EXISTING TECHNICAL SPECIFICATIONS AND BASES  
UNIT 3

PROPOSED TECHNICAL SPECIFICATIONS AND BASES  
UNIT 3

CHANGES TO 15 3.4.8.3.1 PAGES WHICH WERE PREVIOUSLY REQUESTED IN  
AMENDMENT APPLICATION NO. 97 (PCN-358) DATED DECEMBER 20, 1991  
AND ARE BEING REQUESTED IN PCN-359

SAN ONOFRE UNIT 3

FIGURE 3.4-2  
 SONGS 3 HEATUP RCS PRESSURE/TEMPERATURE  
 LIMITATIONS FOR ~~4~~ 8 EFY  
 Normal Operation

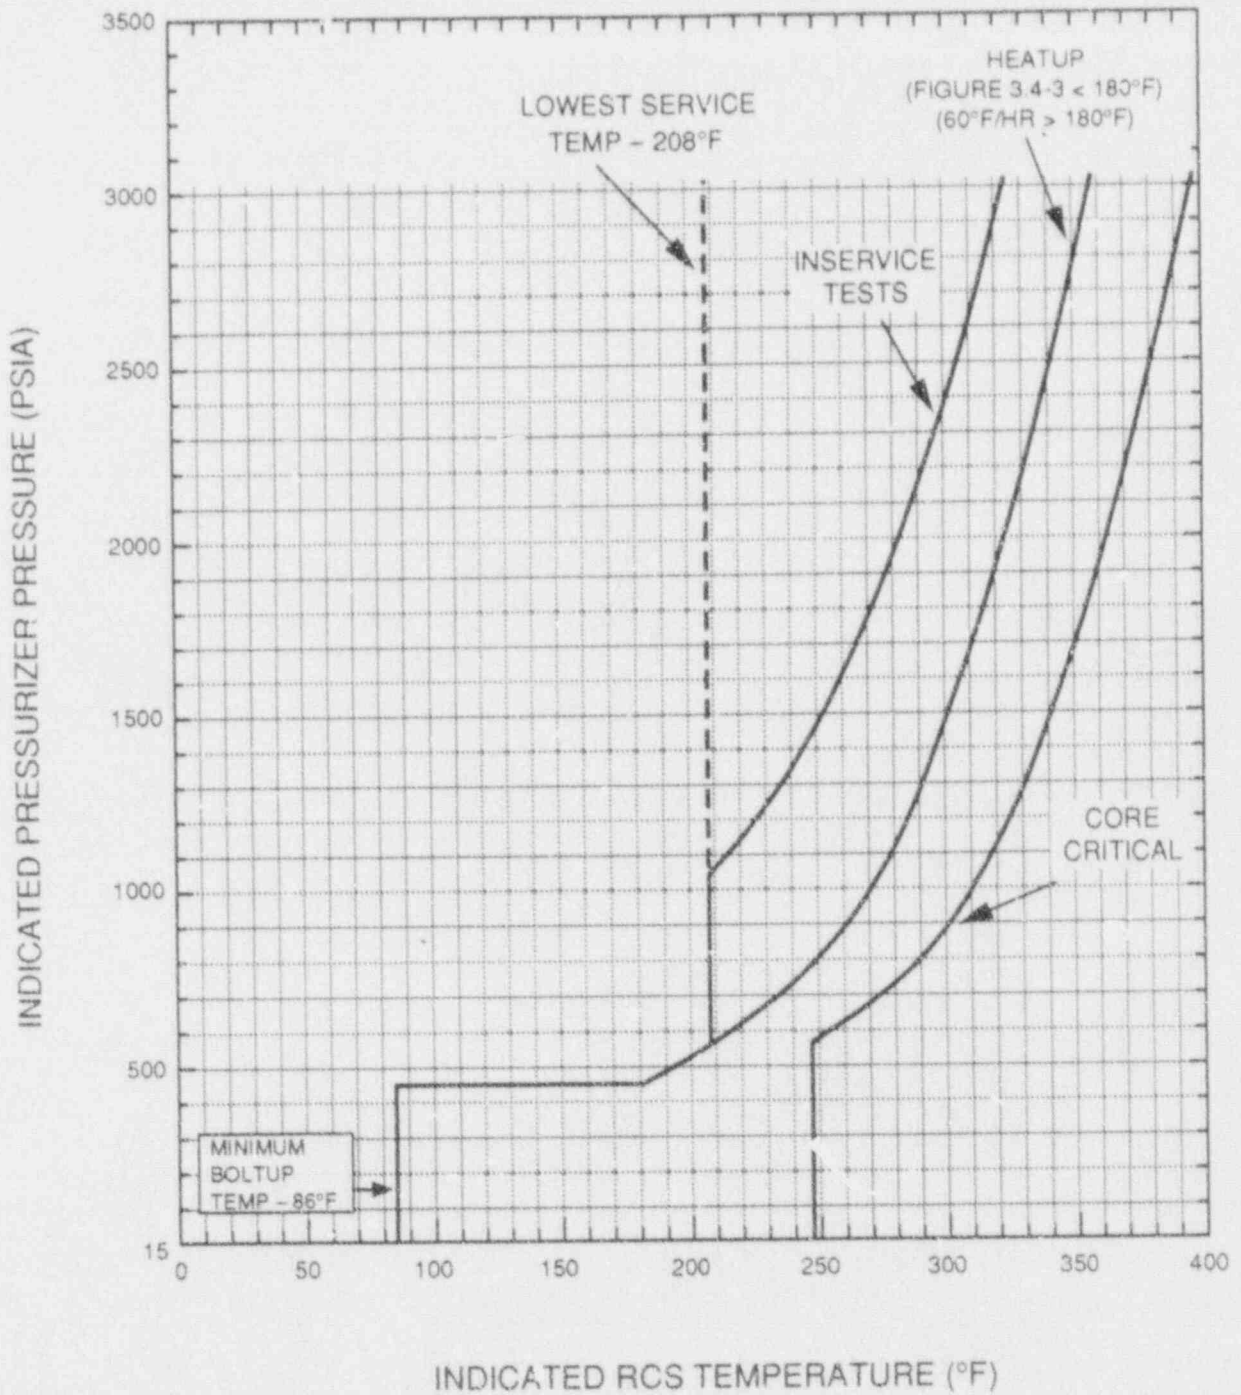
NOTE: A MAXIMUM HEATUP RATE OF 60°F/HR IS ALLOWED  
AT ANY TEMPERATURE ABOVE 153°F 180°F

FIGURE 3.4-3

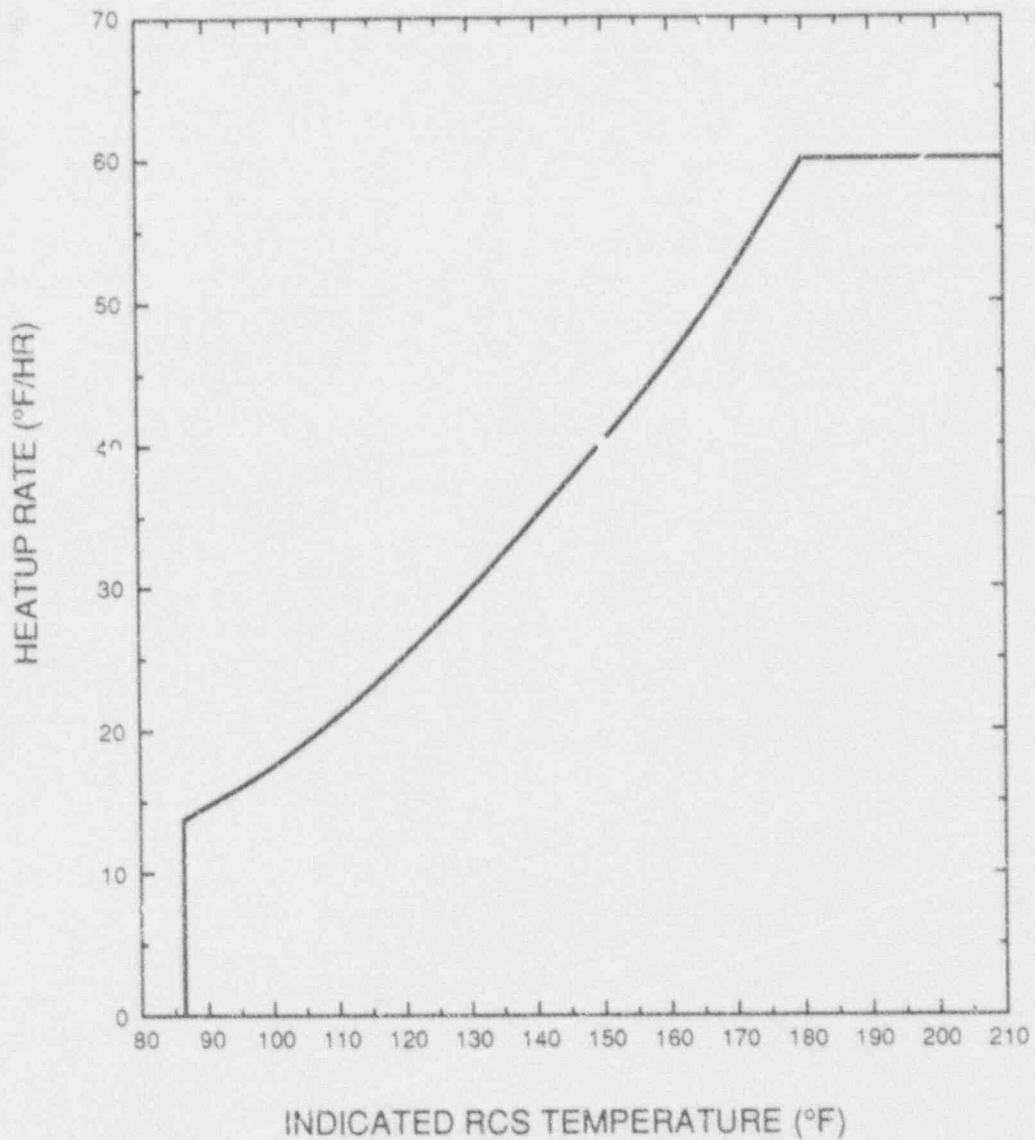
- a. A maximum heatup as specified by Figure 3.4-3 in any 1-hour period with RCS cold leg temperature less than ~~±53~~ 180°F. A maximum heatup of 60°F in any 1-hour period with RCS cold leg temperature greater than ~~±53~~ 180°F.
- b. A maximum cooldown as specified by Figure 3.4-5 in any 1-hour period with RCS cold leg temperature less than ~~±26~~ 175°F. A maximum cooldown of 100°F in any 1-hour period with RCS cold leg temperature greater than ~~±26~~ 175°F.
- c. A maximum temperature change of 10°F in any 1-hour period during inservice hydrostatic and leak testing operations above the heatup and cooldown limit curves.
- d. A minimum temperature of 86°F to tension reactor vessel head bolts.

SONGS 3 RCS PRESSURE/TEMPERATURE LIMITS  
MAXIMUM ALLOWABLE HEATUP RATES (—4— 8 EFPY)  
Normal Operation

FIGURE 3.4-4

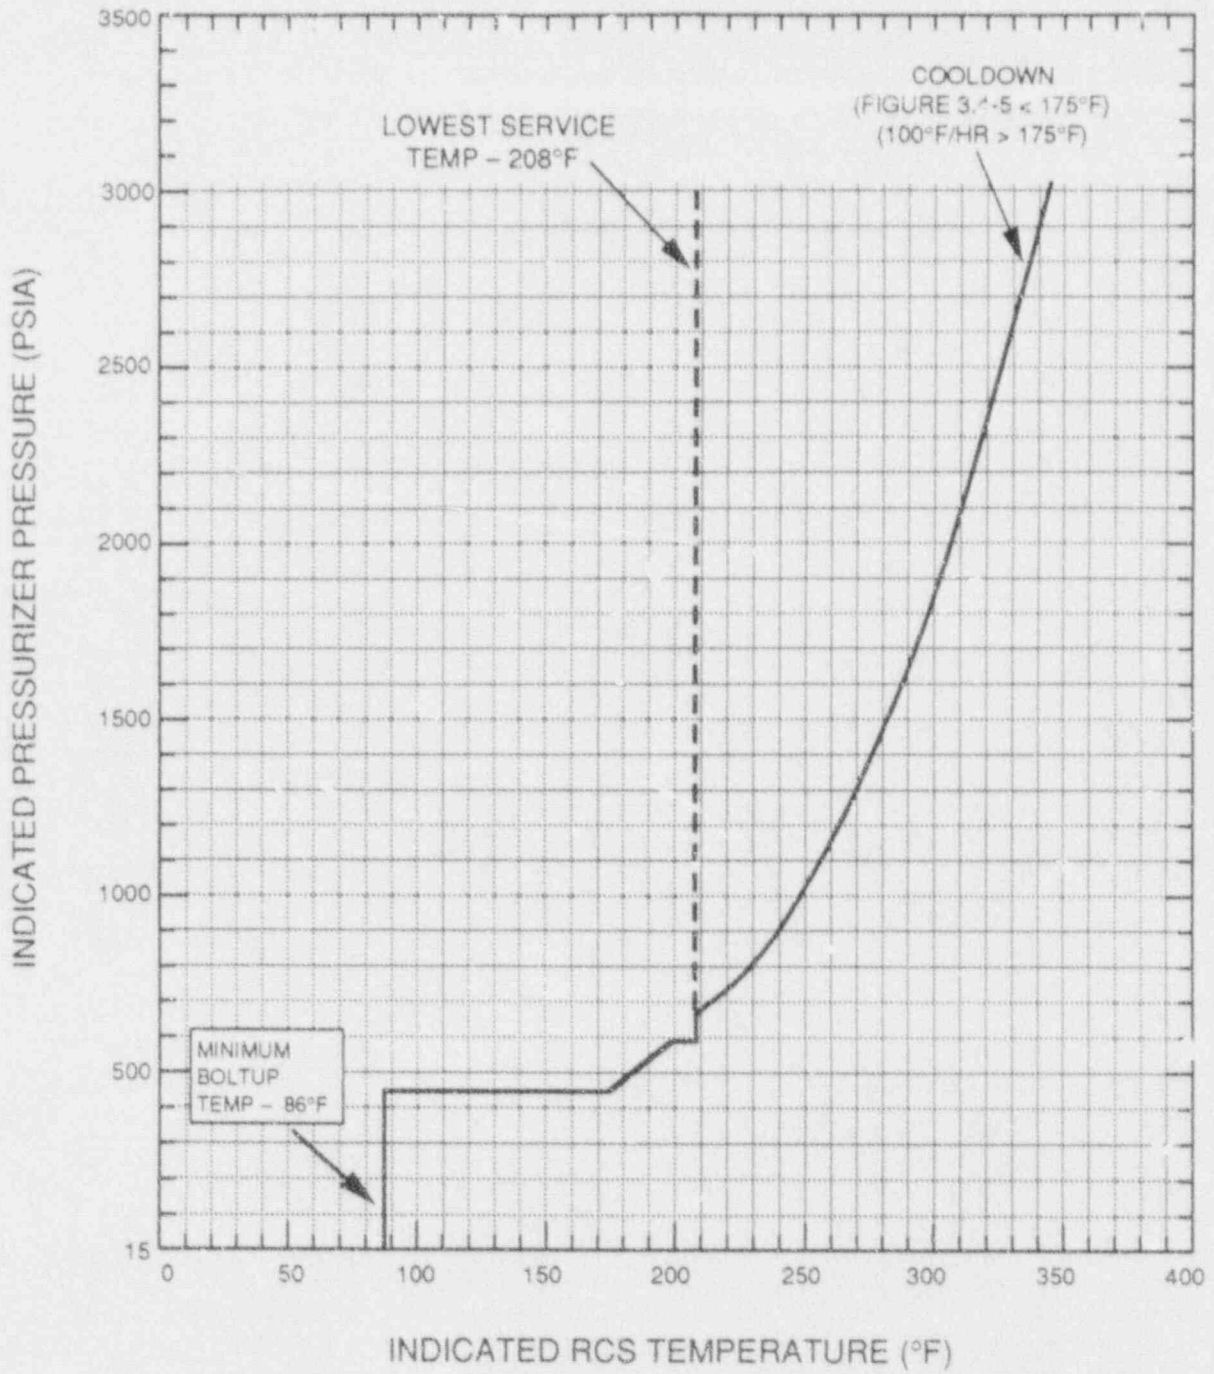
SONGS 3 COOLDOWN RCS PRESSURE/TEMPERATURE  
LIMITATIONS FOR —4— 8 EFPY  
Normal Operation

NOTE: A MAXIMUM COOLDOWN RATE OF 100°F/HR IS ALLOWED  
AT ANY TEMPERATURE ABOVE 126°F 175°F

FIGURE 3.4-5

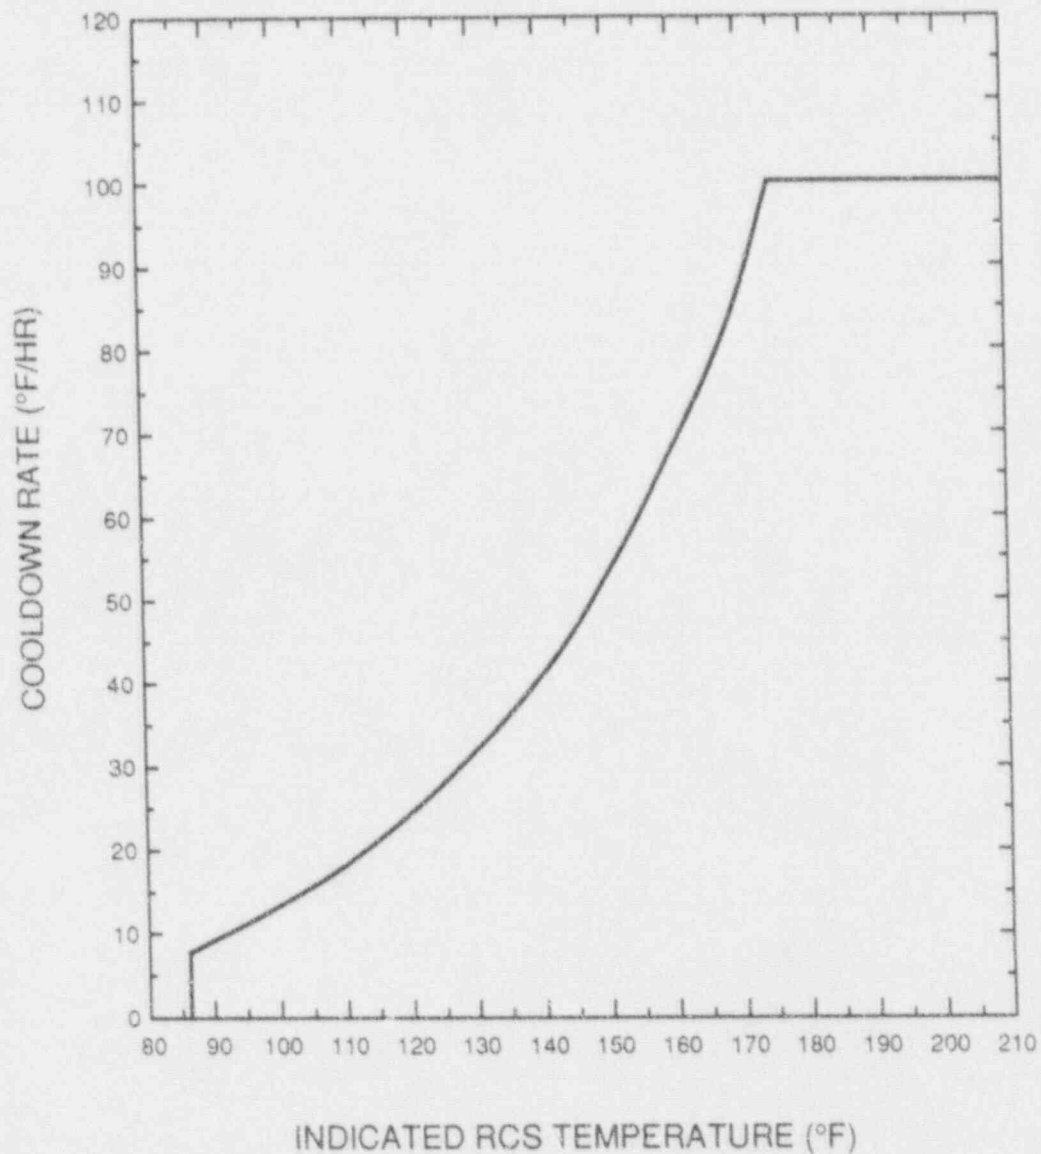
SONGS 3 RCS PRESSURE/TEMPERATURE LIMITS  
MAXIMUM ALLOWABLE COOLDOWN RATES (—4— 8 EFY)  
Normal Operation

FIGURE 3.4-6

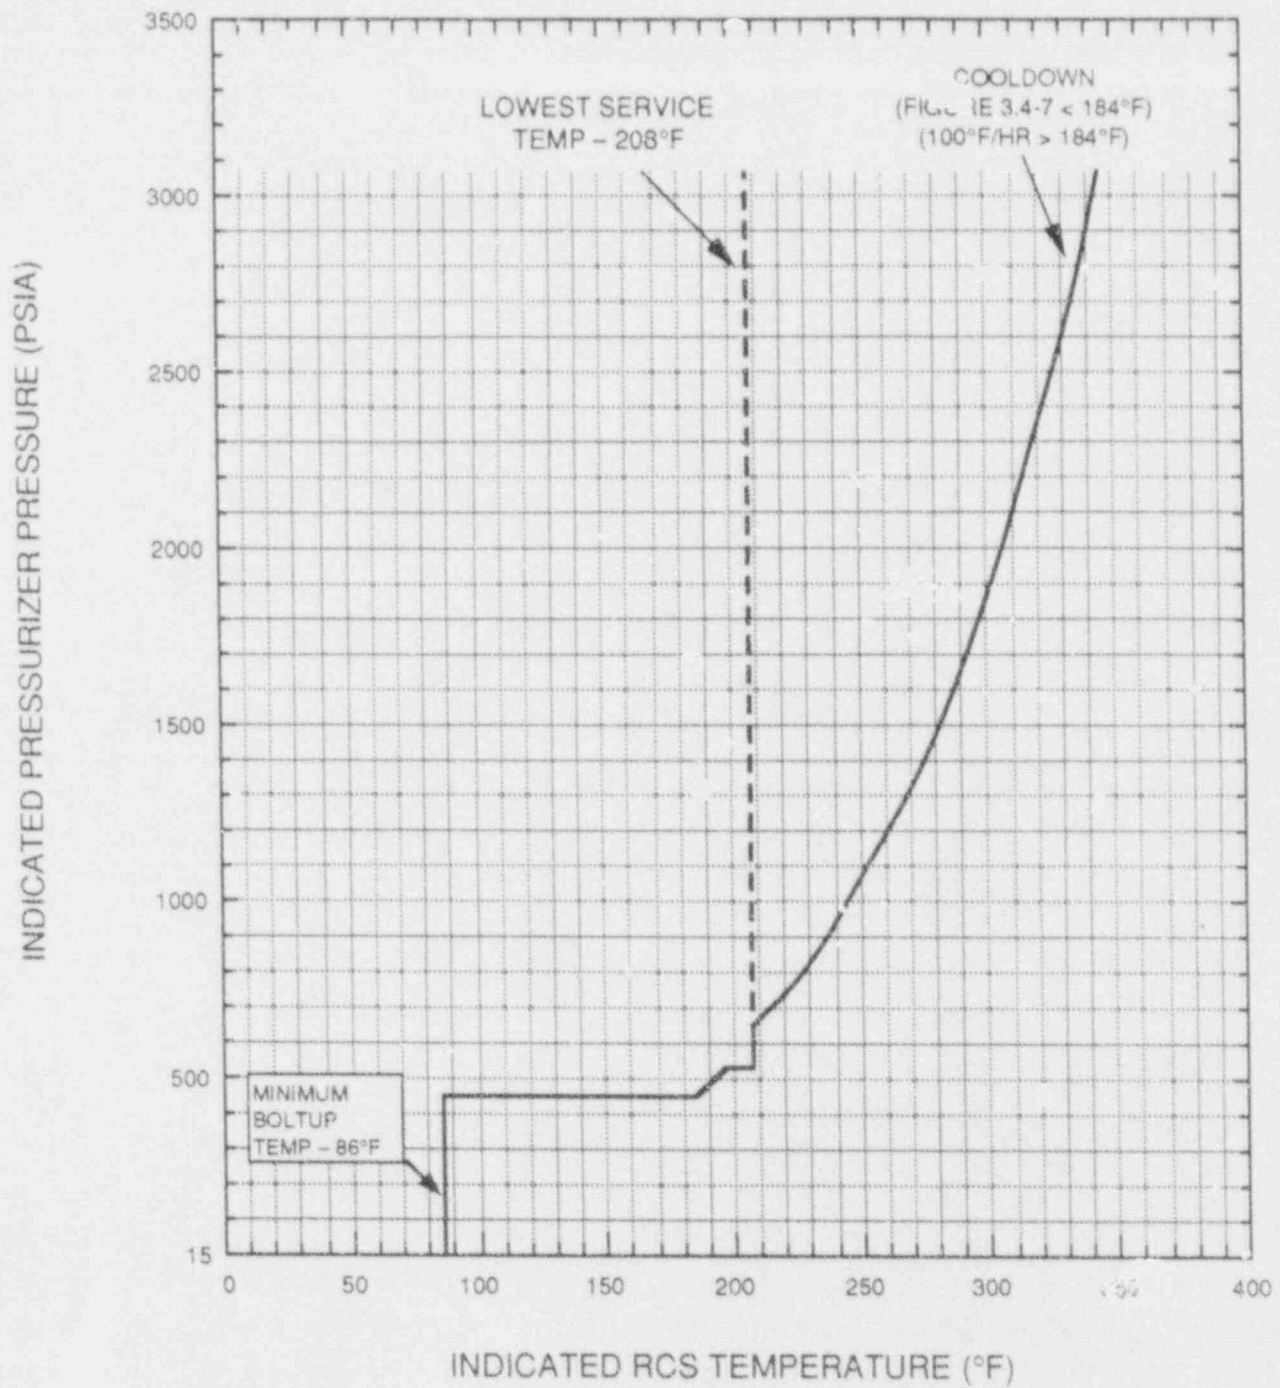
SONGS 3 COOLDOWN RCS PRESSURE/TEMPERATURE  
LIMITATIONS FOR 8 EPY  
Remote Shutdown Operation

NOTE: A MAXIMUM COOLDOWN RATE OF 100°F/HR IS ALLOWED AT ANY TEMPERATURE ABOVE 184°F

The heatup and cooldown limit curves for normal operation (Figures 3.4-2 and 3.4-34) and the cooldown limit curve for remote shutdown operation (Figure 3.4-6) are composite curves which were prepared by determining the most conservative case, with either the inside or outside wall controlling, for any heatup rate of up to 60°F/hr or cooldown rate of up to 100°F/hr. The limit curves for Remote Shutdown operation are determined using the Total Loop Uncertainties (TLUs) for temperature and pressure for the Remote Shutdown Panel instruments in which the pressure TLUs are higher than those for the Control Room shutdown instruments. The heatup and cooldown curves were prepared based upon the most limiting value of the predicted adjusted reference temperature at the end of the service period indicated on Figures 3.4-2 and 3.4-34 for normal operation and Figure 3.4-6 for Remote Shutdown operation.

FIGURE 3.4-7

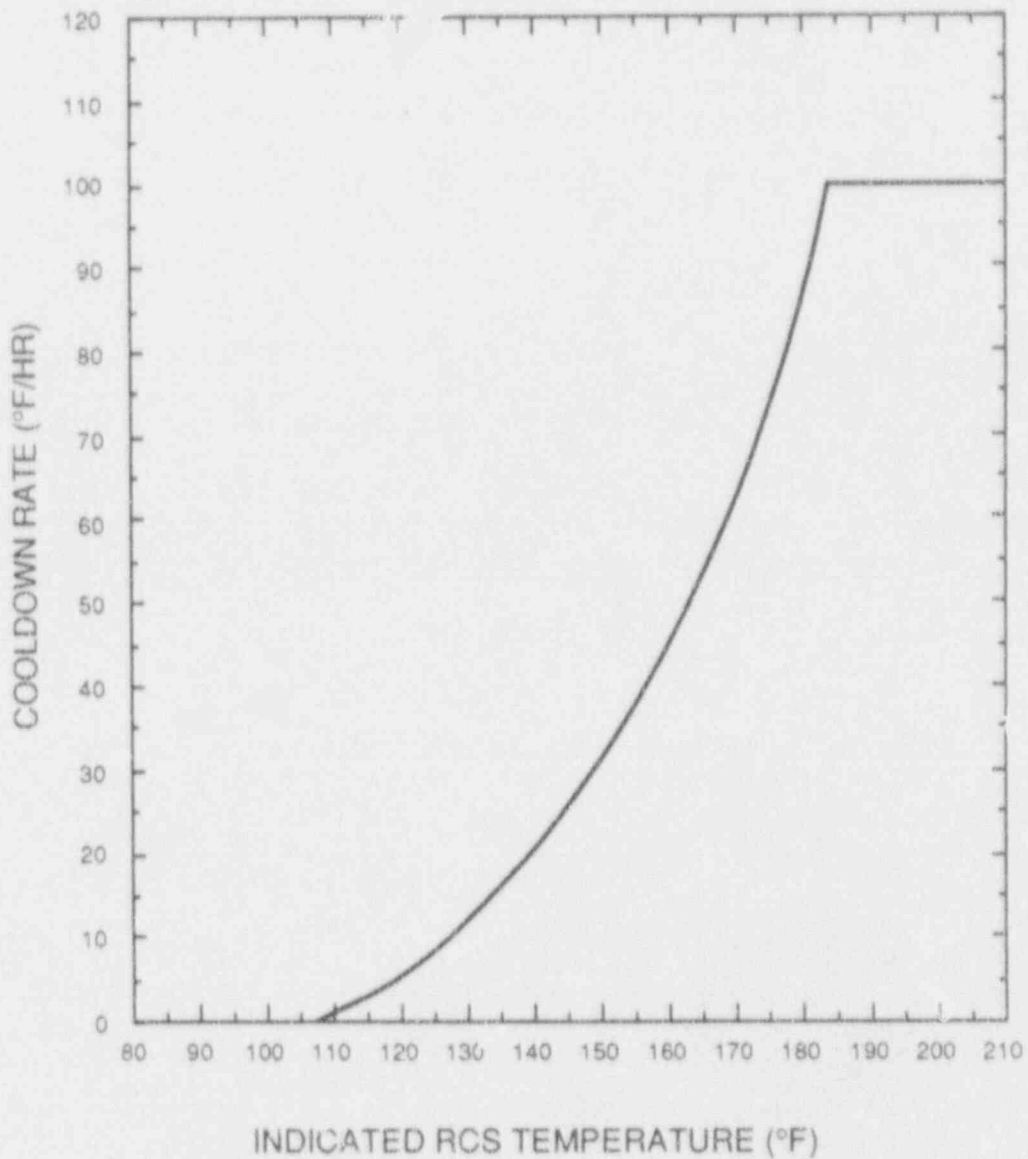
3.4.8.1 With the reactor vessel head bolts tensioned, the Reactor Coolant System (except the pressurizer) temperature and pressure shall be limited in accordance with the limit lines shown on Figures 3.4-2, 3.4-3, 3.4-4, and 3.4-5, 3.4-6, and 3.4-7 during heatup, cooldown, criticality, and inservice leak and hydrostatic testing with:

SONGS 3 RCS PRESSURE/TEMPERATURE LIMITS  
 MAXIMUM ALLOWABLE COOLDOWN RATES (8 EFY)  
 Remote Shutdown Operation
